AMENDMENT OF SOLICITATION/MODIFICATION OF CONTRACT				1. Contract Number	Page of Pages	
2. Amendment/Modification Number DCAM-2011-B-0168-004		3. Effective Date 25-Aug-11	4. Requisition/Purchase Request No.		5. Solicitation Caption Renovation of 611 N Street Women's Shelter

RFI Responses
(Responses are in BLUE italics)

NEW REINFORCED GROUND FLOOR PLAN
 SCALE: 1/8"=1'-0"

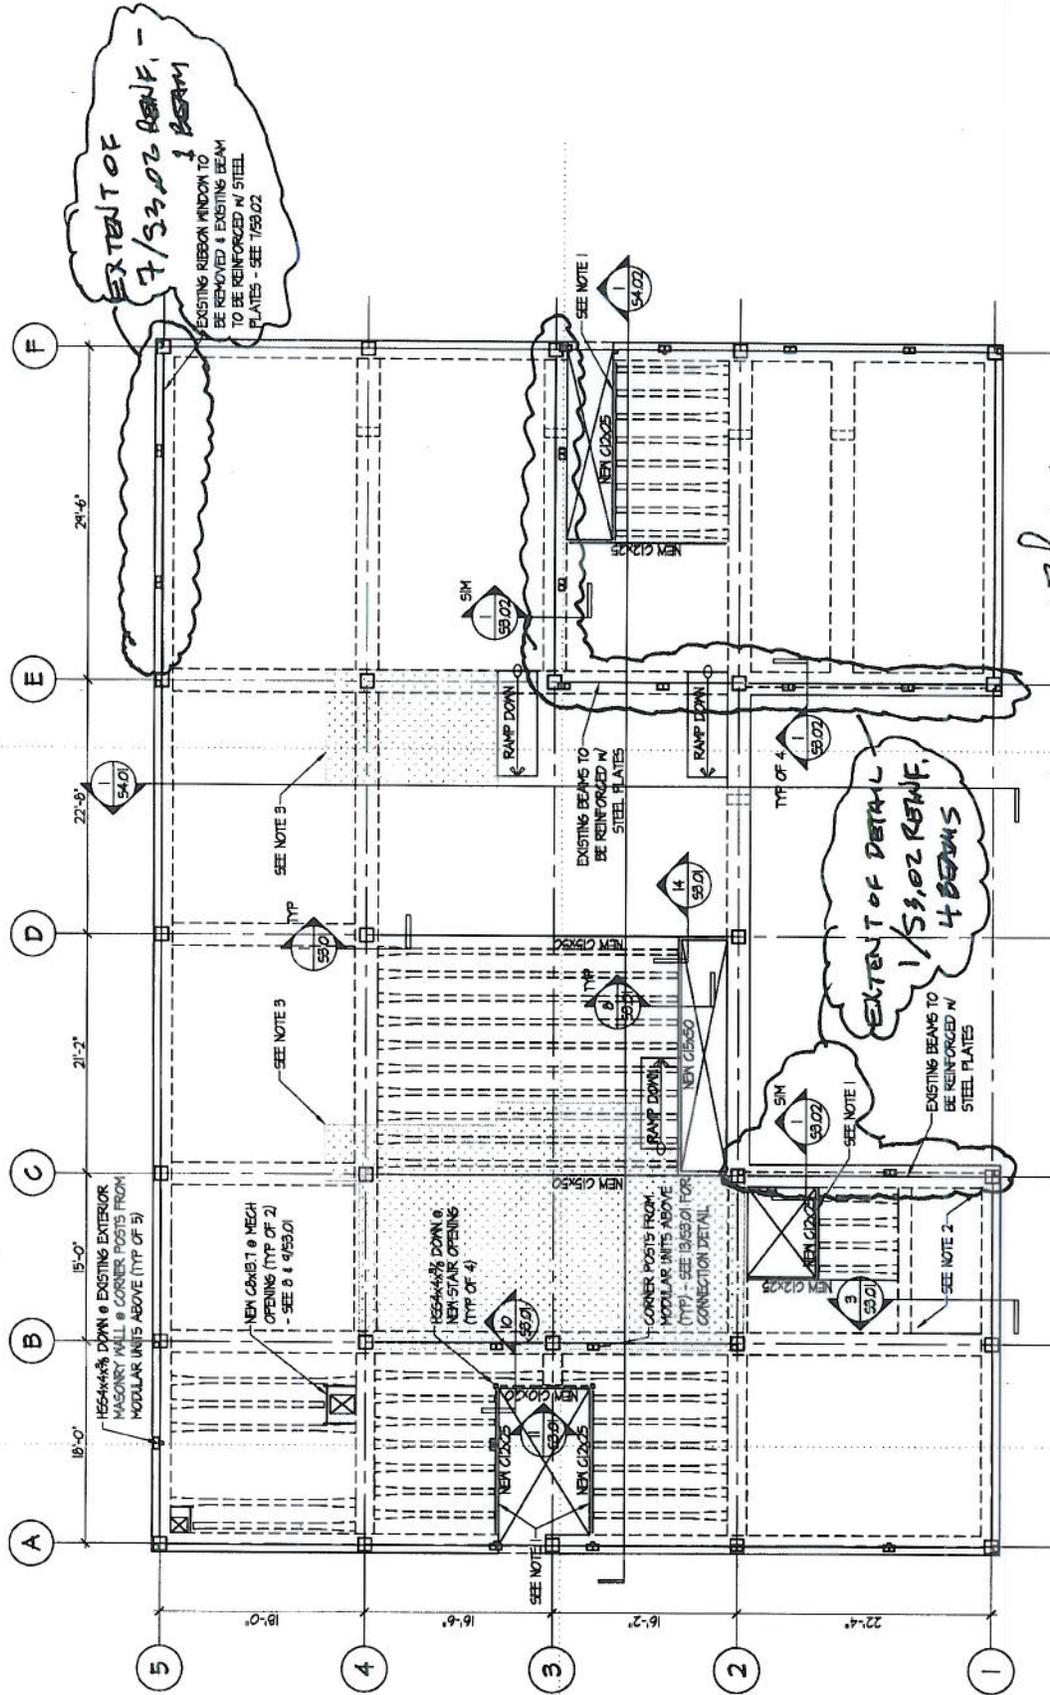
22. Ref. detail 1-S302. It is not possible to determine where this occurs. You cannot estimate the linear footage of existing beams. This is an expensive detail. Please provide a quantity to base our bid on, instead of having the contractors guess at the quantity.

26. Ref. detail 1-S302. It is not possible to determine where this occurs. You cannot estimate the linear footage of existing beams. This is an expensive detail. Please provide a quantity to base our bid on, instead of having the contractors guess at the quantity.

See attached sketch from the structural engineer that clarifies the extent of this detail.

EXTENT OF 7/53.02 REMF. - 1 BEAM
 EXISTING RIBBON WINDOW TO BE REMOVED & EXISTING BEAM TO BE REINFORCED W/ STEEL PLATES - SEE 1/53.02

EXTENT OF DETAIL 1/53.02 REMF. 4 BEAMS
 EXISTING BEAMS TO BE REINFORCED W/ STEEL PLATES
